Work Order ID 93255

Item Name: Fwd Clip

APICAL INDUSTRIES, INC.	ENGINEERING CHANGE NOTIC NO. 03266				SHEET 1 OF 2	
	DWG NO. 647.9000	REV: N/C	PREPARED BY A. QUAN	DATE: 11/15/11	EFFECT ON DWG <input type="checkbox"/> INC. <input checked="" type="checkbox"/> UNINC.	
	DWG TITLE: SHEETMETAL					
APPROVED BY: ENGR <i>[Signature]</i>		MFG <i>[Signature]</i>	QC <i>[Signature]</i>	EFF: CURRENT ORDER AND STOCK		
TRANSACTION CODES (TC) A-ADD C-CREATE R-REVISE D-DELETE		REASON: REVISED 647.9014 MATERIAL, REVISED DIMENSIONS OF P/N 647.9012

APICAL INDUSTRIES, INC.	ENGINEERING CHANGE NOTIC. NO. 03213				SHEET 1 OF 1	
	DWG NO. 647.9000	REV: N/C	PREPARED BY A. QUAN	DATE: 11/09/11	EFFECT ON DWG <input type="checkbox"/> INC. <input checked="" type="checkbox"/> UNINC.	
	DWG TITLE: SHEETMETAL					
	APPROVED BY: ENGR. <i>[Signature]</i>	MFG <i>[Signature]</i>	QC <i>[Signature]</i>	EFF: CURRENT ORDER AND STOCK		
TRANSACTION CODES (TC) A-ADD C-CREATE R-REVISE D-DELETE	REASON: REVISED 647.9013 DIMENSIONS

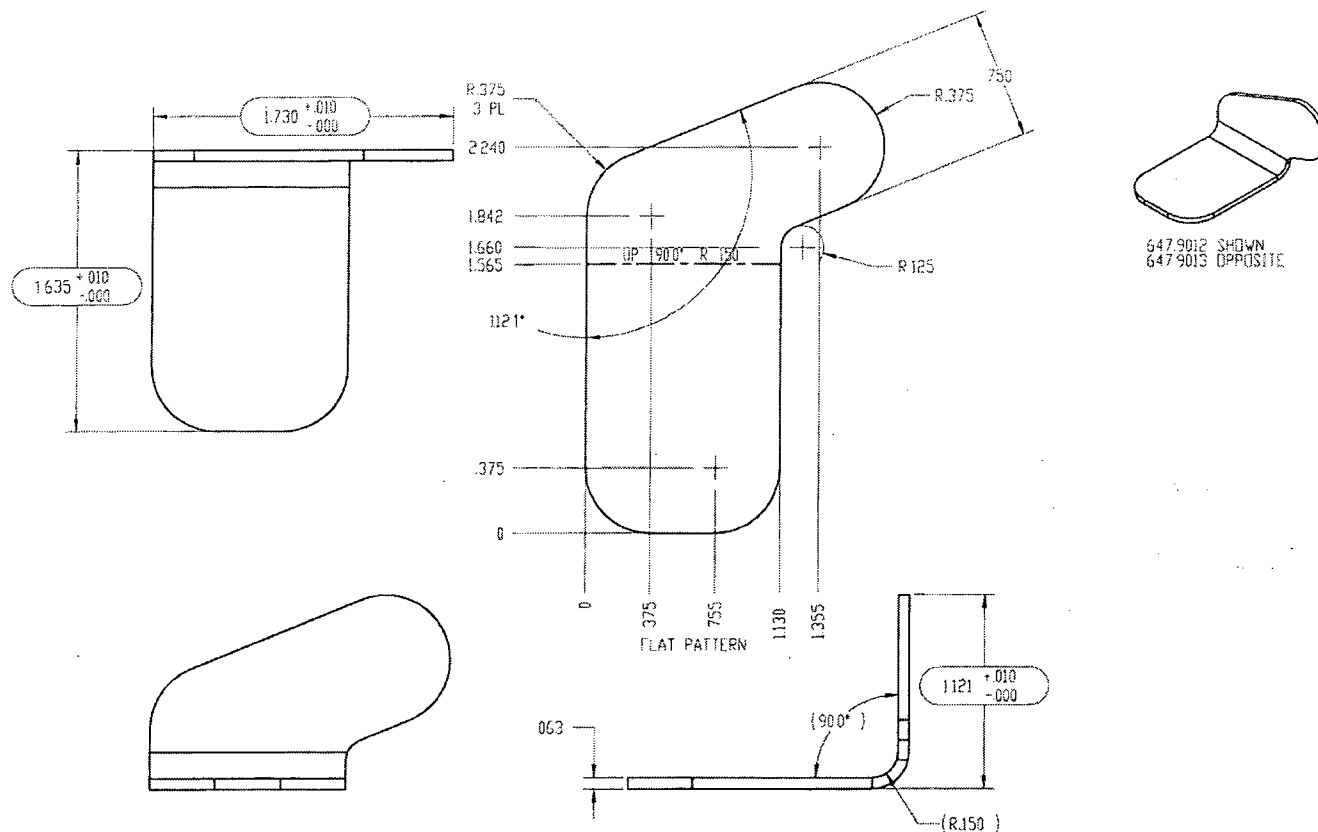
- 1 MATERIAL: ALUMINUM 2024-T3 PER AMS-QQ-A-250/4
- 2 FINISH: HARD ANODIZE IAW MIL-A-8625 TYPE III, CLASS 2, COLOR BLACK;
PRETREAT PR-148 ADHESION PROMOTER, PRIME IAW MIL-P-23377J, TYPE I, CLASS N
3. DEBURR AND BREAK ALL SHARP EDGES
4. IDENTIFY IAW MPP-120. LASER ETCH P/N AND REVISION 12PT. CENTURY GOTHIC.
5. ALL DIMENSIONS SHOWN PRIOR TO FINISH.
- 6 PART DIMENSIONS CONTROLLED BY CAD MODEL; FILE NAME: 647.9016 DOUBLER.SLDPRT-LAST MODIFIED 06-29-10
7. INSPECTION DIMENSIONS SHOWN WITH FINISH APPROX. 3-5 MIL MAX PER FACE.
- 8 MATERIAL: 304SS IAW AMS 5643
- 9 FINISH: PRIME IAW MIL-P-23377J, TYPE I, CLASS N
